Model 2002 Natural Water Purifier

The Model 2002 replaces the Model 2001 Natural Water Purifier. The unit has been improved to allow connection to GFI protected power sources. The input power wiring is different. The unit operation remains the same as the Model 2001.

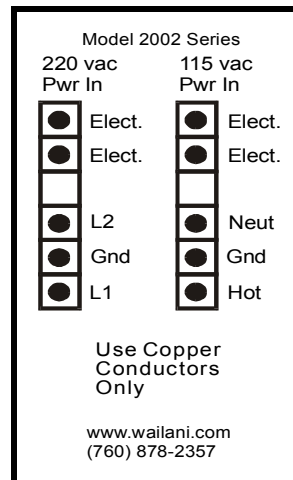
The input power is connected as shown below:

The circuit board has been modified to allow for selection of 115 vac or 220/240 vac input power. The unit is shipped set for 220/240 vac operation. Install the selection jumper on the circuit board connector J4 as follows:
